**JAFP-16-0157**

ENTERGY NUCLEAR OPERATIONS, INC.  
JAMES A. FITZPATRICK NUCLEAR POWER PLANT  
EMERGENCY PLAN IMPLEMENTING PROCEDURE

PROTECTIVE ACTION RECOMMENDATIONS  
EAP-4C  
REVISION 2

## REVISION SUMMARY SHEET

1. Attachment 1, Page 1 - Revised the formatting on Initial Protective Action Recommendation ONLY Flowchart by splitting the Rapidly Progressing Severe Accident decision box as follows:

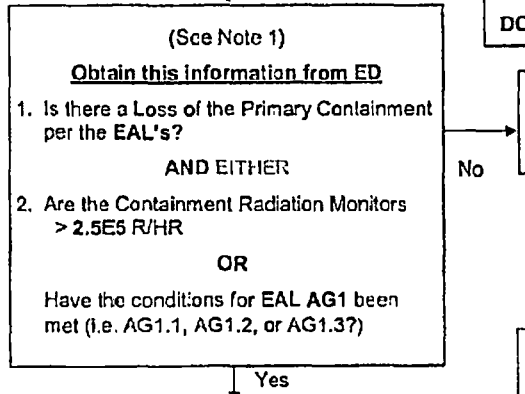
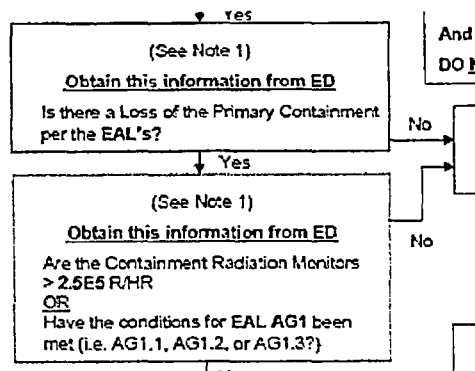
Change #1 from Part I - This is a formatting change with no change to the content or intent. This splits a question box which previously had two questions in it. This change is editorial in nature in accordance with EN-AD-101. It does not change the intent or purpose of the procedure. No further evaluation is required.
